TECHNICAL DATA BULLETIN

ATC & COLLINS CARTRIDGE RECORDERS

FIG. 1. COLLINS/ATC A-190 & A-150

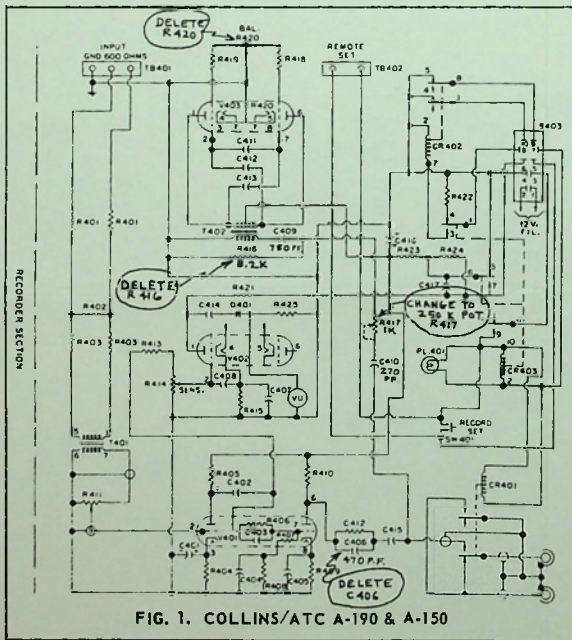
1. **A-190 and A-150 recording amplifiers.** (See Fig. 1) This type is recognizable by the push-pull bias oscillator circuit. Perform the following steps:

(a) Incorporate adjustable bias by replacing the fixed 1K resistor, R417, with a 250K potentiometer (preferably with linear taper). It may be mounted on the chassis of the recording amplifier in place of the oscillator balance control, R420, which is completely unnecessary. This will save drilling a hole. Connect the clockwise lug of the new control to C409 so that clockwise rotation of the shaft will increase the bias current. Connect the 270 pf. C410 to the wiper. Ground the grid resistors R418 and R419.

(b) Increase the bias voltage by deleting the 8.2K load resistor, R416.

(c) Reduce the high-frequency pre-emphasis on recording by deleting the 470 pf. capacitor, C406, which shunts R412. The original circuit boosts the 10kc. recording current by as much as 17 db. over the 1 kc. current, while the laminated heads only require about 10 kc. of boost for correct frequency response. If the ability to adjust the high-frequency record pre-emphasis is desired, then the 25 pf. C403 may be replaced with an adjustable mica trimmer capacitor of around 5-80 pf.

FIG. 2. CUE CHANNEL COUPLING

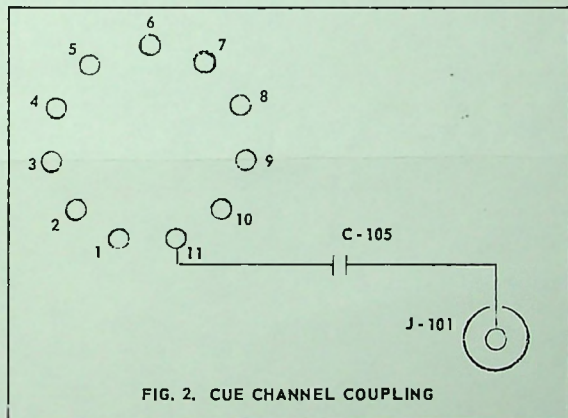
2. **A-150, A-190, P-190 cue channel triggering.** (See Fig. 2) Additional circuit modification is necessary with these amplifiers, if the cue channel does not trigger with the NORTRONICS #3000, 3001, 3200, or 3201 head.

When using the 800 mhy head (#3000 or 3200) replace the cue head coupling capacitor (C-105, 0.5 mfd) with a 0.03 mfd capacitor. With the 400 mhy head (#3001 or 3201) replace C-105 with a 0.05 mfd capacitor. The capacitor goes between the cue head jack (J-101) and pin #11 of S-101.

The cue head is connected through C-105 to the cathode of V-301A. V-301A serves as a two stage preamplifier on playback, with the grid of V-301A grounded, and the signal from the cue head fed to the cathode. By changing C-105 to a value which resonates with the head at the 1000 cps cue tone, the overall sensitivity of the head is greatly improved, because the low impedance cathode is being driven with a series resonant circuit.
